CERTIFICATE OF APPROPRIATENESS

Property: 1005 Heights Blvd, Lot 10, Block 216, Houston Heights Neighborhood Subdivision. The property includes a historic 2,921 square foot, two-story single-family residence and detached garage situated on a 7,500 square foot interior lot.

Proposal: Alteration – Addition, Siding, Windows

SECOND FLOORPLAN

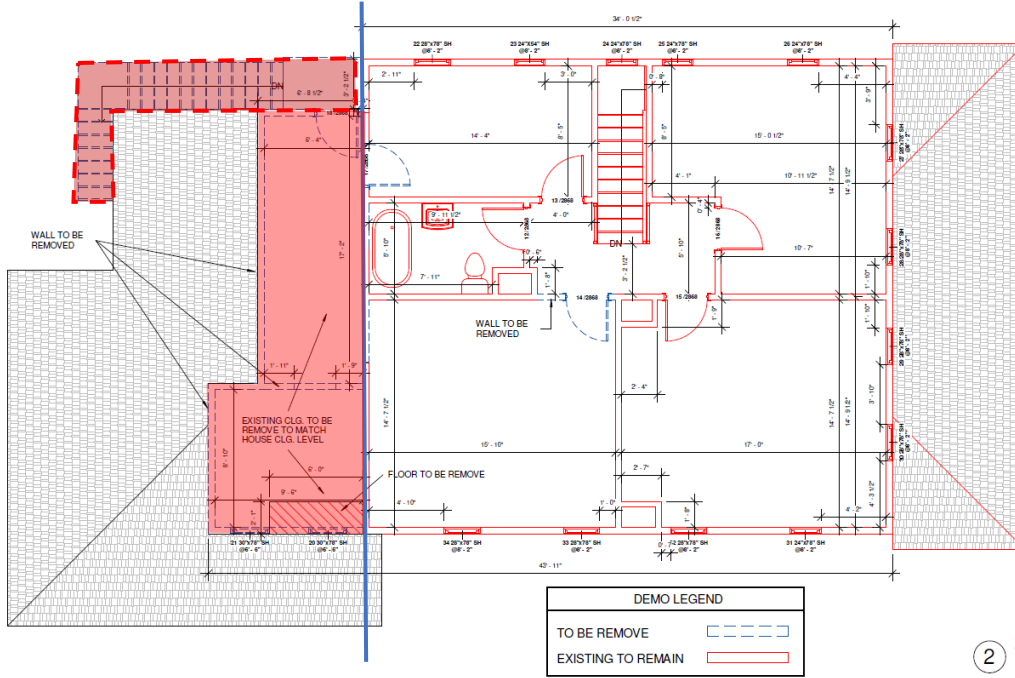
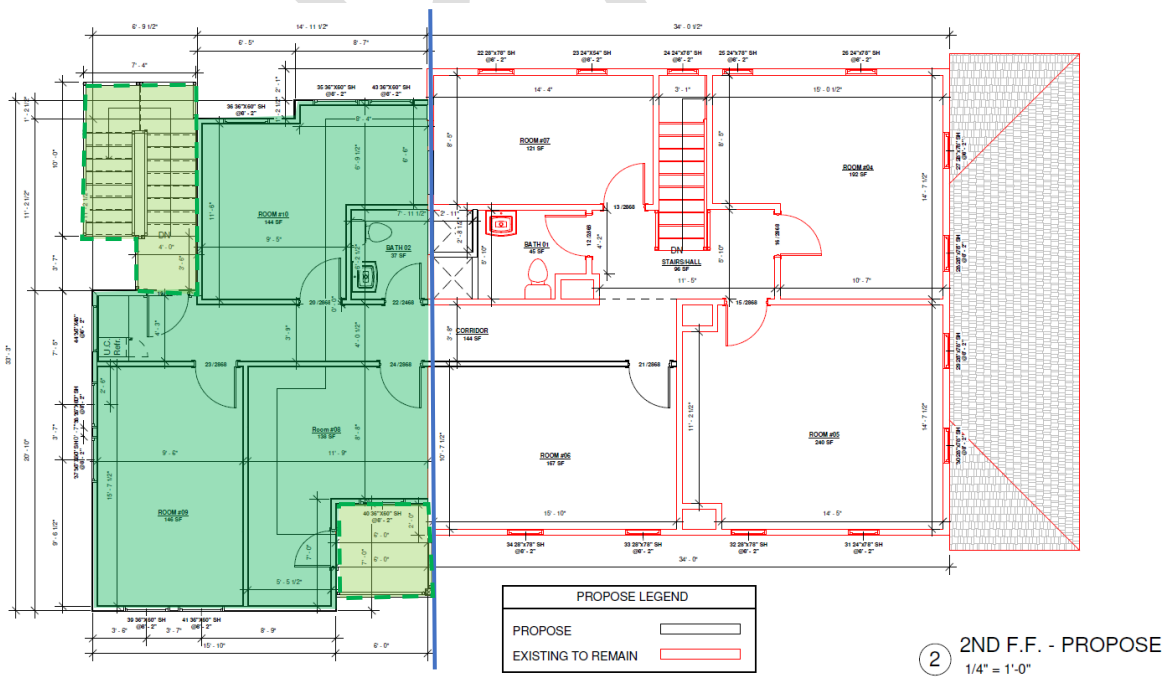
Recommendation: Approval with conditions: Extend the porch on second-floor addition to meet the edge of the existing wall below and to eliminate the small roof overhang.

WEST (REAR) ELEVATION

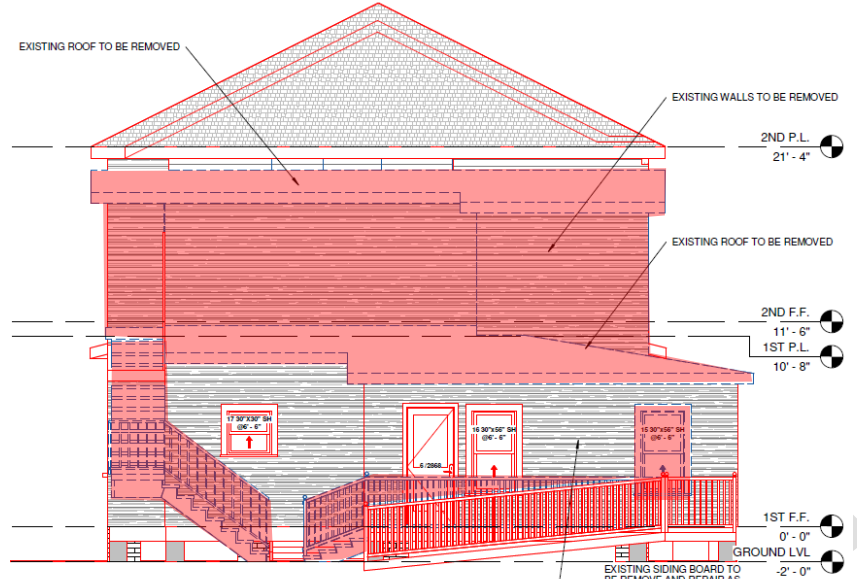
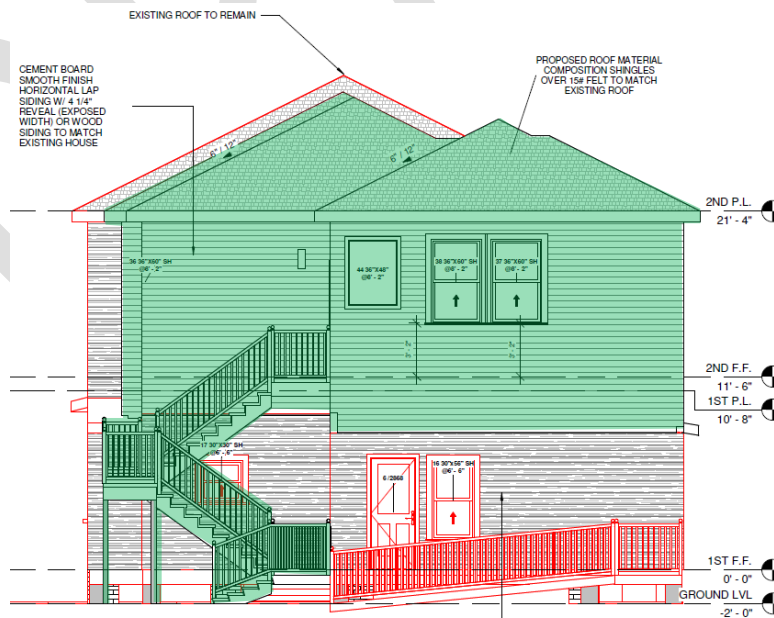
EXISTING SIDING BOARD TO BE REMOVE AND REPAIR AS NEEDED TO INSTALL ADDITIONAL INSULATION ON EXISTING HOUSE. THE PROPOSED MATERIAL TO REPAIR WILL MATCH EXISTING SIDING WITH 4 1/4" REVEAL (EXPOSED WIDTH)

EXISTING SIDING BOARD TO BE REMOVE AND REPAIR AS NEEDED TO INSTALL ADDITIONAL INSULATION ON EXISTING HOUSE. THE PROPOSED MATERIAL TO REPAIR WILL MATCH EXISTING SIDING WITH 4 1/4" REVEAL (EXPOSED WIDTH)

SOUTH (LEFT) ELEVATION

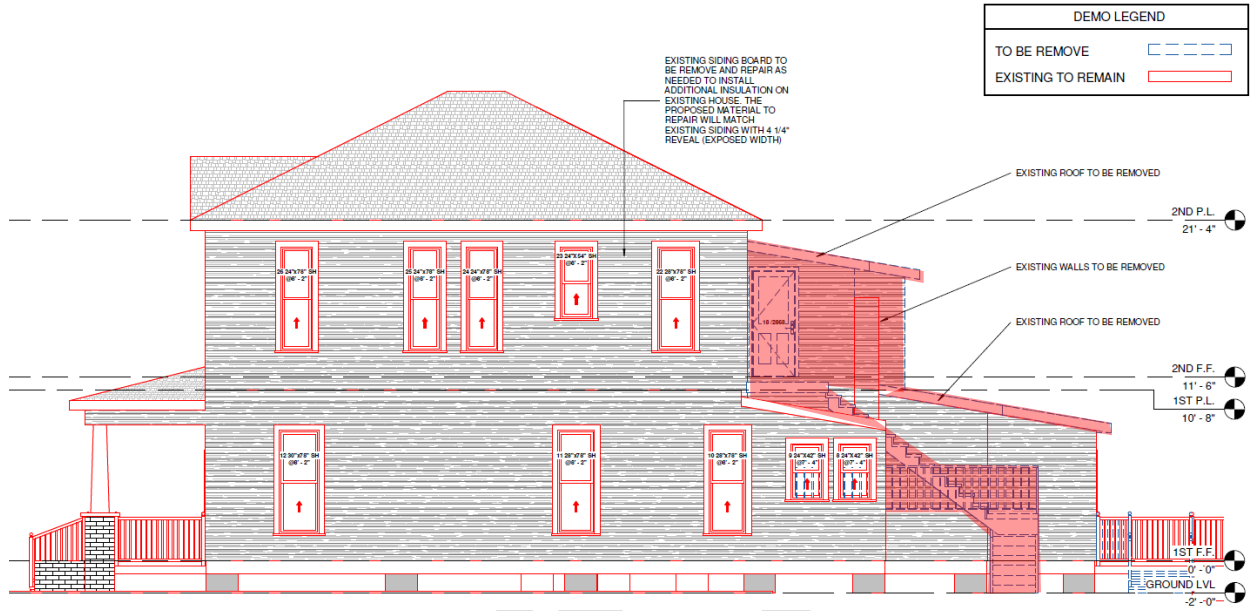
- o A small side porch will be added to the second story at the front corner of the addition on the south (left) elevation. The porch is visible from the public right-of-way, maintains the original corner of the historic house, and is in the rear 50% of the building.

WINDOW DIAGRAM

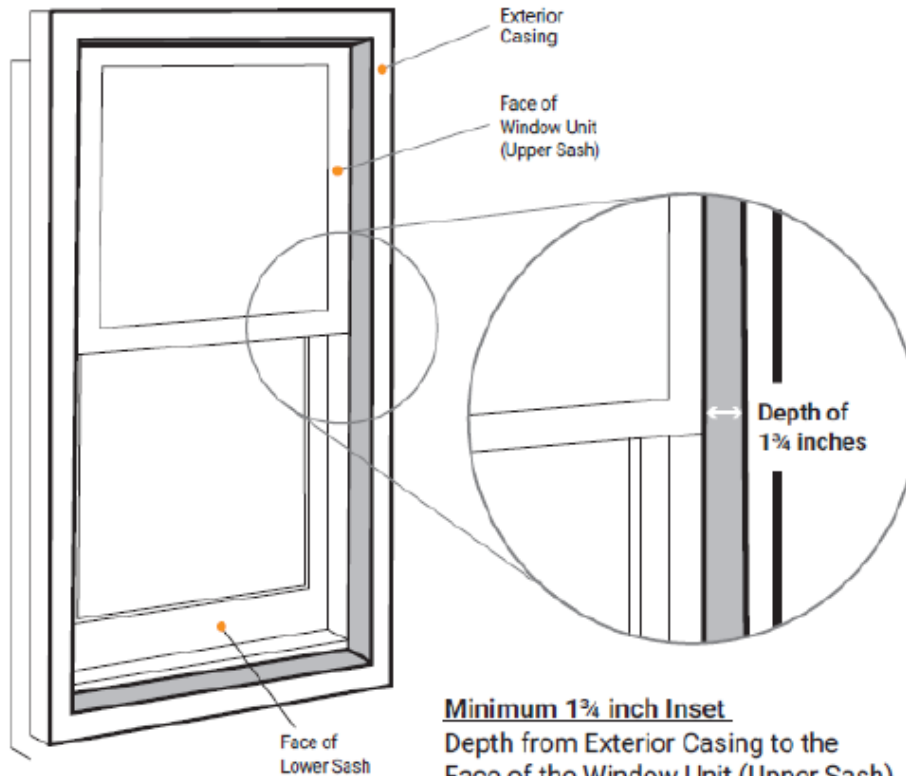
- Windows are to be wood, inset and recessed. Existing windows are to be repaired. **See the diagram on pg.37** for further information regarding dimension specifications for new windows.

Minimum 1¾ inch Inset
 Depth from Exterior Casing to the
 Face of the Window Unit (Upper Sash)

Windows must be 1-over-1
 (equally horizontally divided)

1¾ inch minimum inset for Fixed Window
